HEATER AND AIR CONDITIONER SYSTEMS

The following points shown in this section are changed in comparison with Mazda 626 Station Wagon Workshop Manual Supplement (1182-10-88B).

CONTROL PANEL

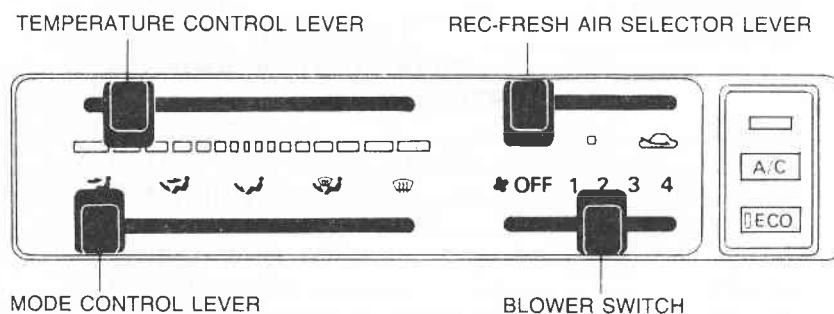
1. The A/C relay is changed.
2. The ECONO switch in the control panel is discontinued. (LHD)

A/C RELAY

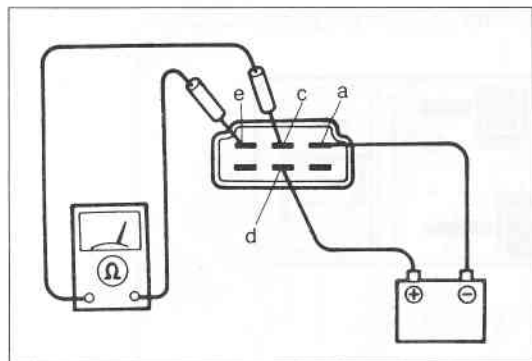
A/C relay

- Inspection

1. Apply 12V to the following terminals, and check continuity of the A/C relay with an ohmmeter.

Order	Terminal condition		Continuity terminal c—e
	a	d	
1	—	—	No
2	Ground	12V	Yes

2. If the continuity is not as specified, replace the A/C relay.
